December 22, 2005

SUBJECT: SR-142, MP 20.2, XL-2617  
Bowman Creek Fish Passage  
Addendum 1 to the Geotechnical Report  
Geotechnical Recommendations

This memorandum is to document the changes to the subject project since the publication of our Geotechnical Report dated June 9, 2005. Due to scour issues, neither a three-sided reinforced bottomless culvert, nor structural plate bottomless pipe arch are feasible at this site. A wider opening is required to prevent scouring down to bedrock. In meetings with the Project Design Office, Bridge and Structures, E&EP Hydraulics, and Geotechnical Division, we concluded that a bridge founded on bedrock would be the preferred option. The centerline alignment has shifted to the south approximately 3 ft. The new structure will be approximately 60 ft long and 32 ft wide. The bridge approaches will be supported by retaining walls.

Figure A-2: Plan

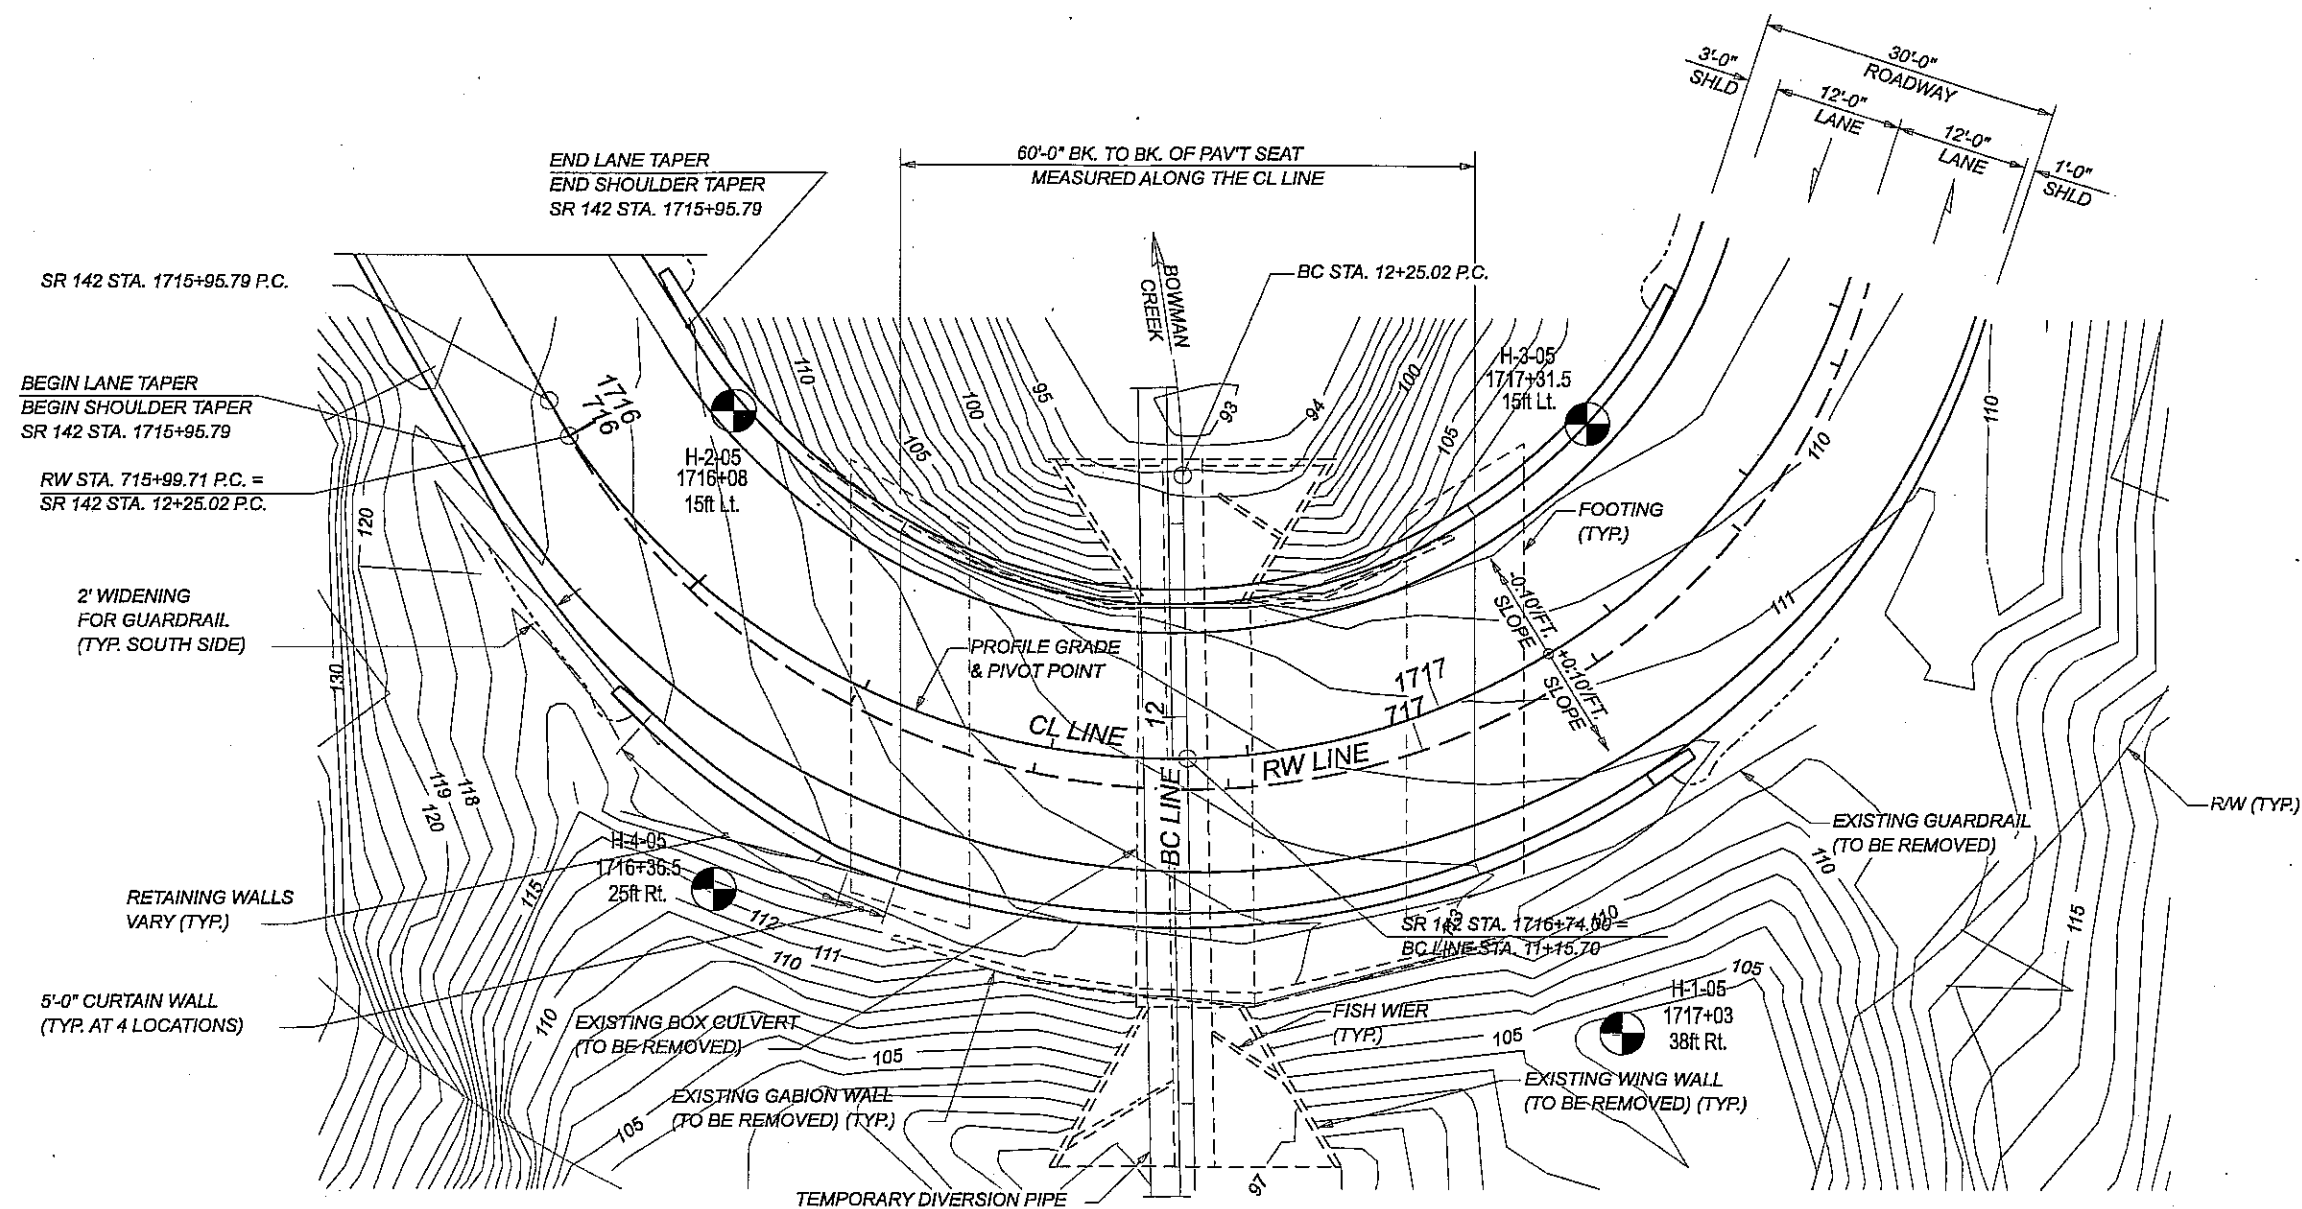
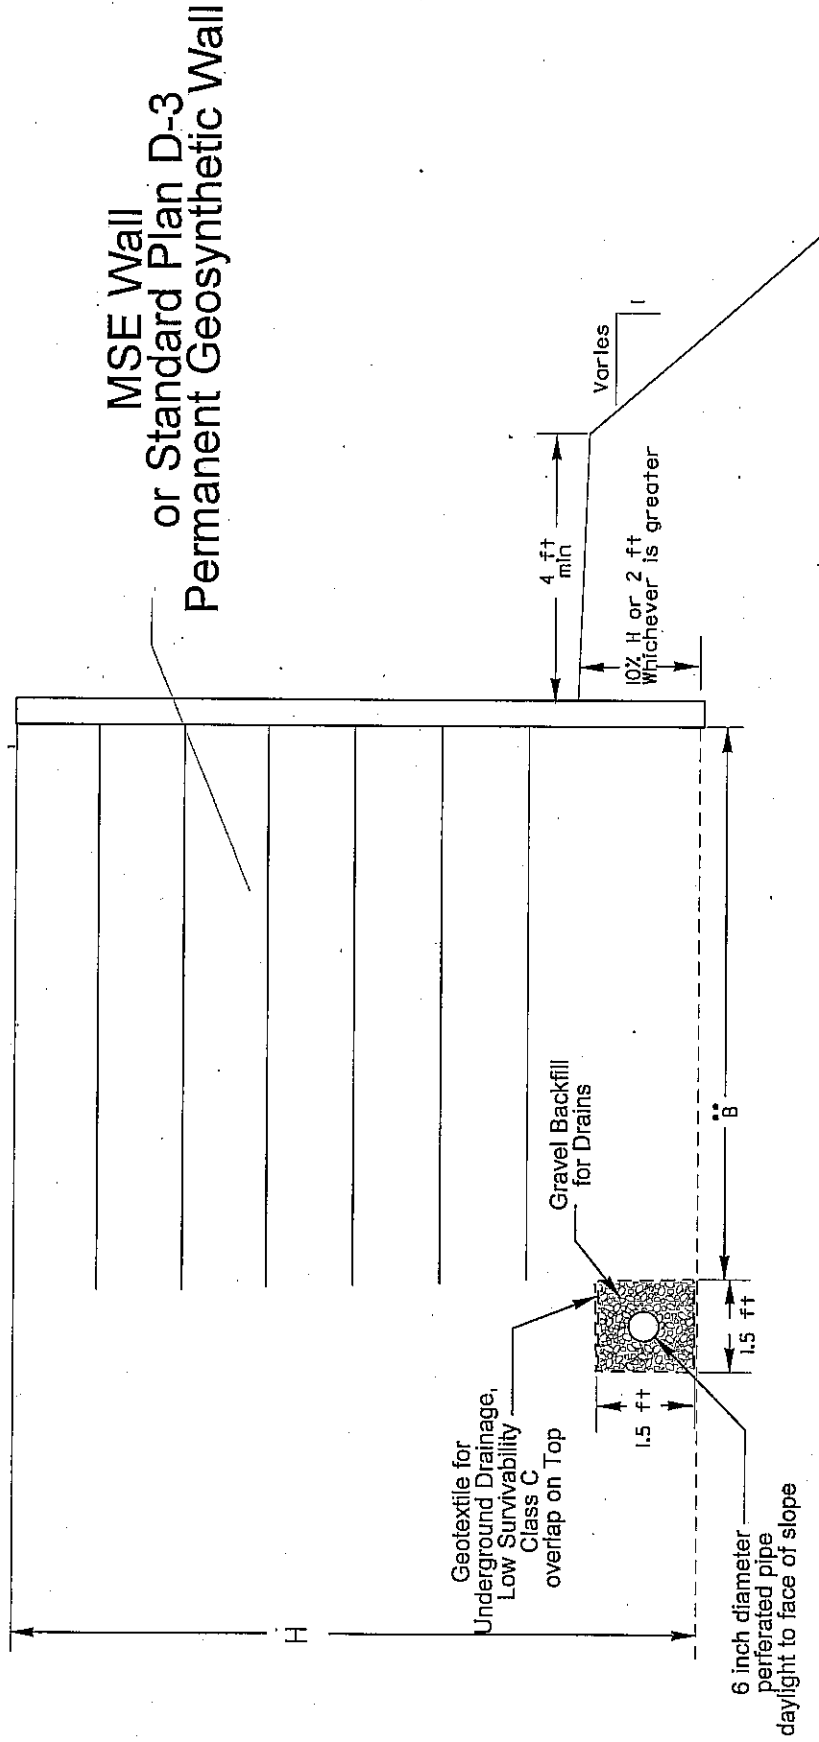
Please note the these rock elevations are interpolated based on the rock contacts measured in the existing test holes as shown in Figures A-2 and A-3. The actual rock elevations may vary under the footing.

Attached are revised figures, which shows the current bridge location and revised alignment. In addition, we have revised the test hole logs to the current stations and offsets.
